鋼板の熱処理装置とそれを備えた鋼板の製造ライン

International application No.
PCT/JP2005/000946

Applicant's or agent's file reference 2004S01366	FOR FURTHER ACTION	See item 4 below	
International application No. PCT/JP2005/000946	International filing date (day/month/year) 19 January 2005 (19.01.2005)	Priority date (day/month/year) 21 January 2004 (21.01.2004)	
International Patent Classification (8th See relevant Information In Form F	n edition unless older edition indicated) PCT/ISA/237		
Applicant JFE STEEL CORPORATION

WRITTEN OPINION OF THE INTERNATIONAL SEARCHING AUTHORITY

図4

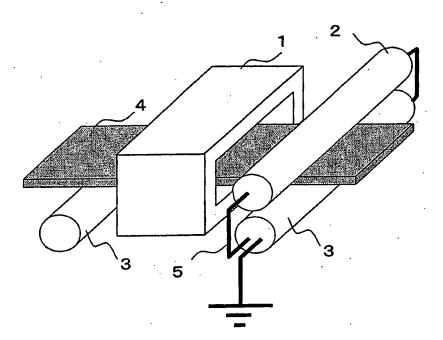
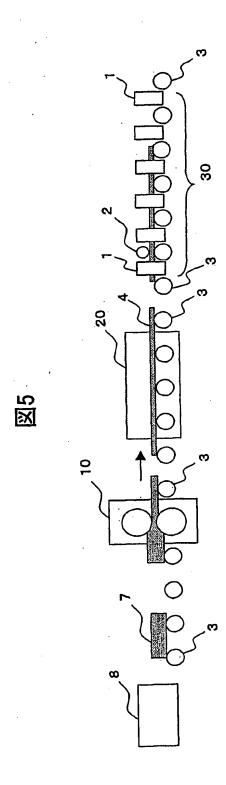
The subject matters of claims 11 and 12 appear to be novel as they are not disclosed in any of the documents cited in the ISR. In particular, it is not disclosed in any document that a conveying roll and a pressing roll are connected by an electric wire to form a closed circuit. The subject matters of claims 11 and 12 appear to involve an inventive step in view of the documents cited in the ISR. Document 1 does not describe that a conveying roll and a pressing roll are connected by an electric wire to form a closed circuit, whereas the invention of the present application thereby exhibits an advantageous effect of preventing sparks.

The subject matters of claims 11 and 12 appear to be novel as they are not disclosed in any of the documents cited in the ISR. In particular, it is not disclosed in any document that a conveying roll and a pressing roll are connected by an electric wire to form a closed circuit. The subject matters of claims 11 and 12 appear to involve an inventive step in view of the documents cited in the ISR. Document 1 does not describe that a conveying roll and a pressing roll are connected by an electric wire to form a closed circuit, whereas the invention of the present application thereby exhibits an advantageous effect of preventing sparks.

請求の範囲11,12に係る発明は、国際調査報告で引用された何れの文献にも開 示されておらず、新規性を有する。特に、搬送ロールと押しつけロールとを導電線で 結び閉回路を形成とする点は、何れの文献にも開示されていない。

請求の範囲11,12に係る発明は、国際調査報告で引用された文献に対して進歩 性を有する。文献1には搬送ロールと押しつけロールとを導電線で結び閉回路を形成 とする点はが記載されておらず、一方、本願発明はそれによりスパークの発生を防ぐ という有利な効果を発揮する。
